Kaipara District Council

BC210456

Site Address: 752 Settlement Road Hakeru

Project Description: Second Hand Relocatable 4 Bedroom Dwelling - Foundations and Drainage Only

Drawn B. C. Wood
Scale 1:400 (A3)
Date 19.07.2021
Sheet 100
Rev 3 add FFL
Job No 21038

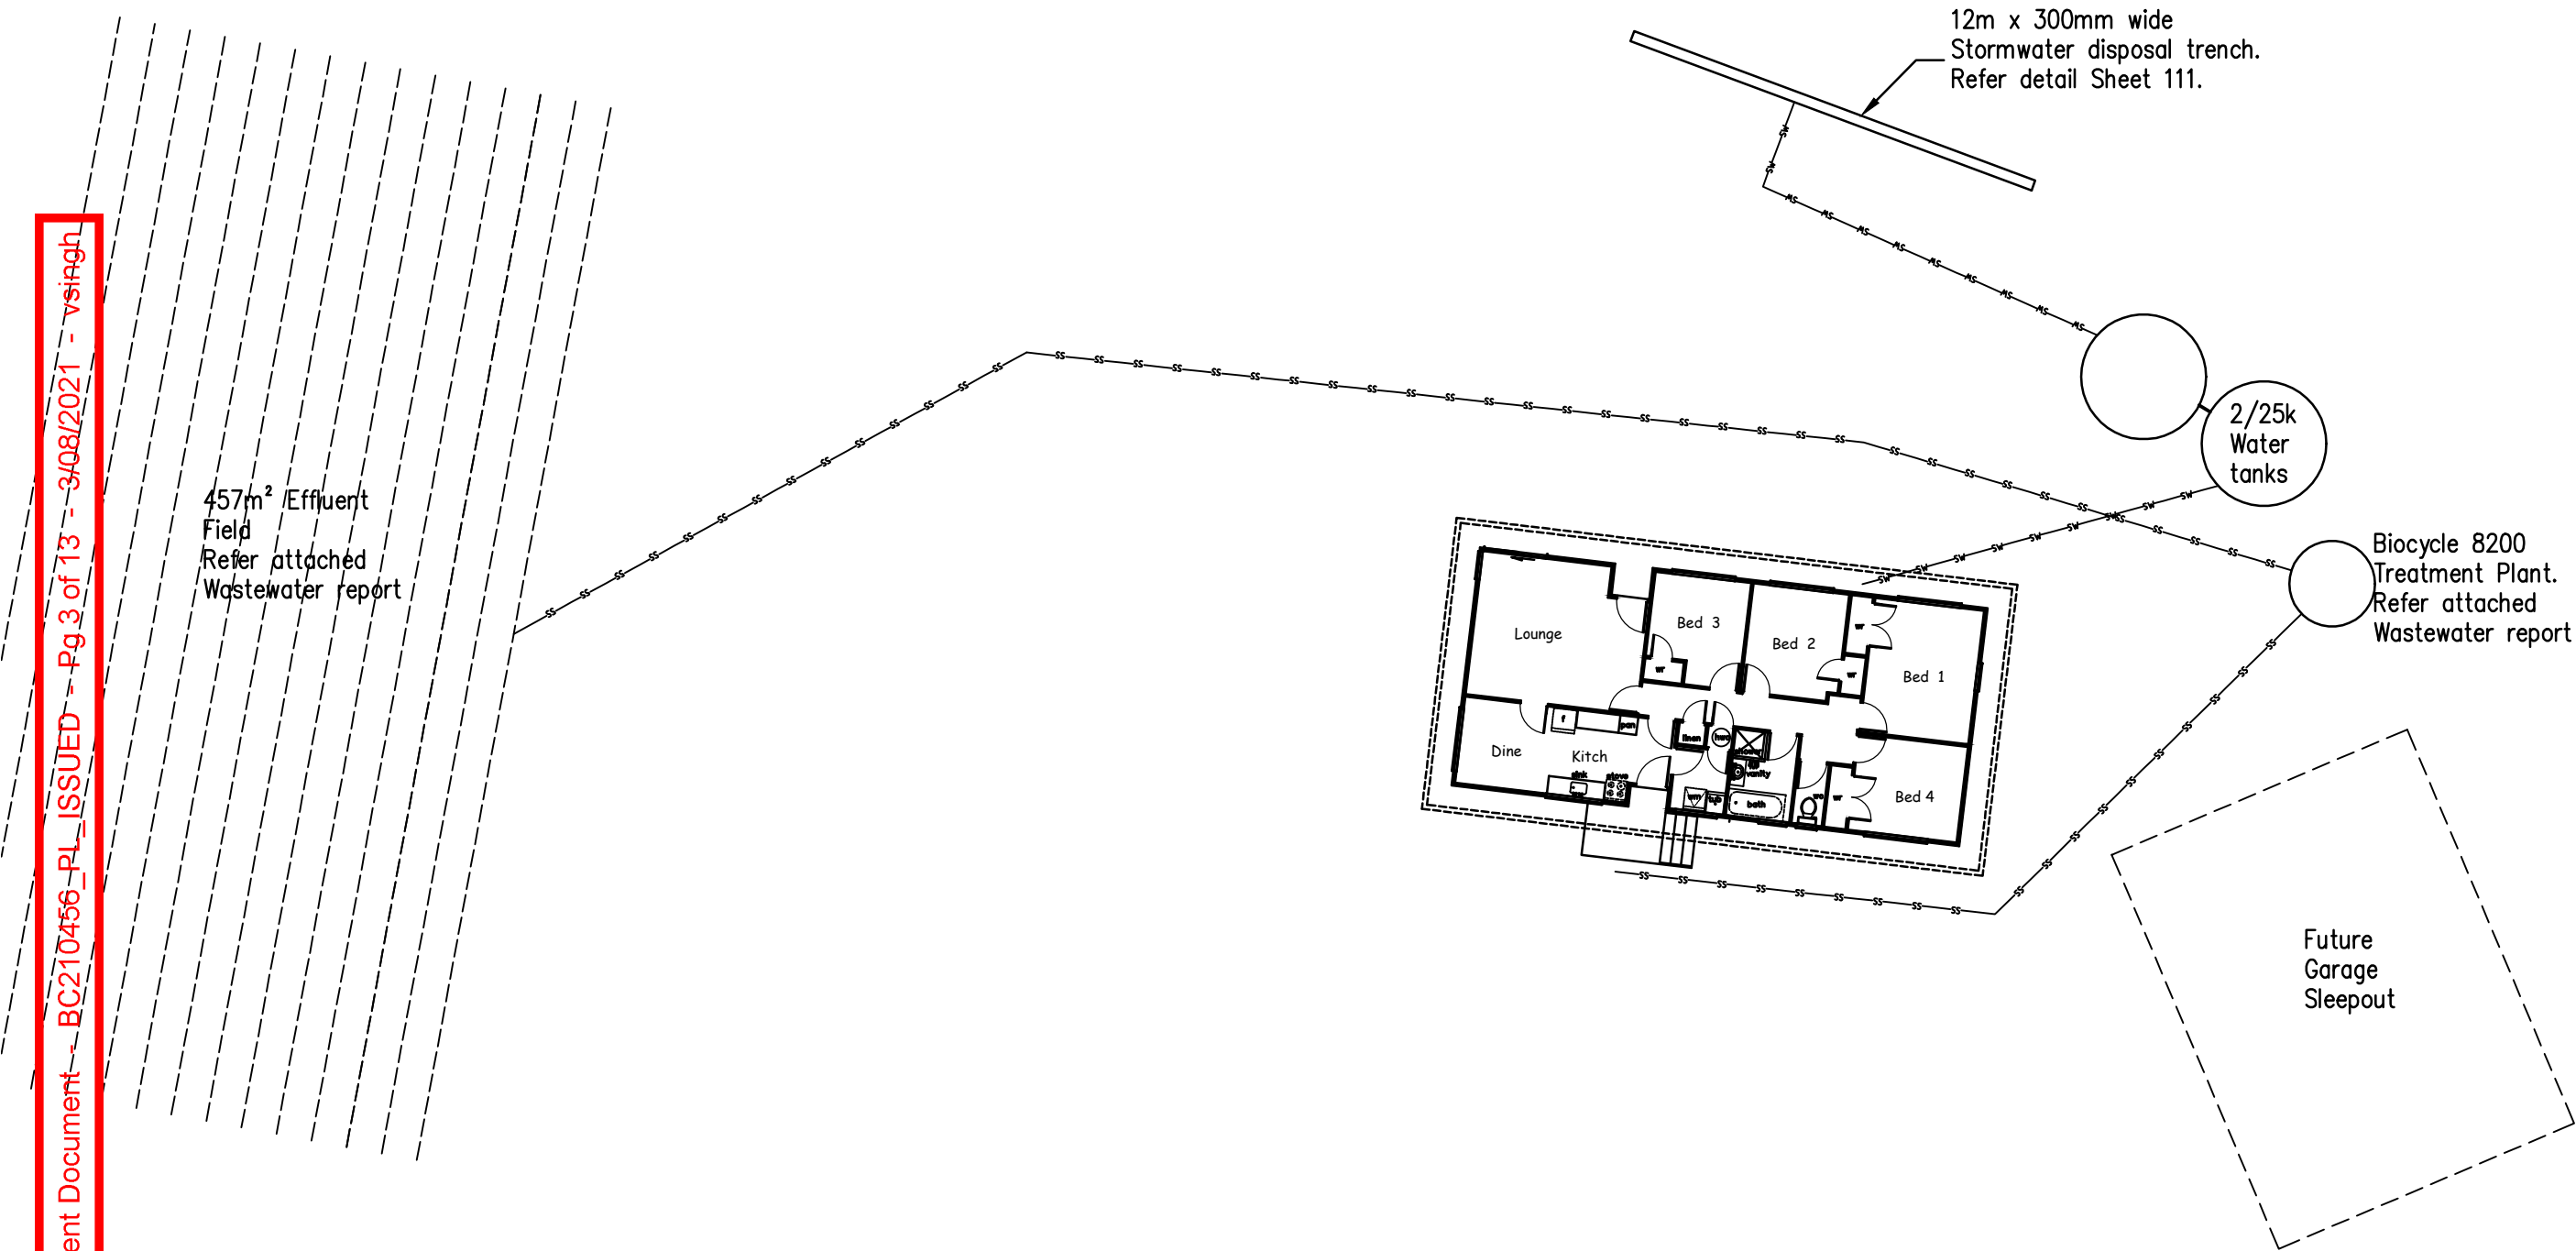
Thanks for those, just in terms of rev sheet 100, two parking spaces need to be supplied with turning circles, the current design shows the second car park obstructing the turning area.

Thanks for those, just in terms of rev sheet 100, two parking spaces need to be supplied with turning circles, the current design shows the second car park obstructing the turning area.

Thanks for those, just in terms of rev sheet 100, two parking spaces need to be supplied with turning circles, the current design shows the second car park obstructing the turning area.
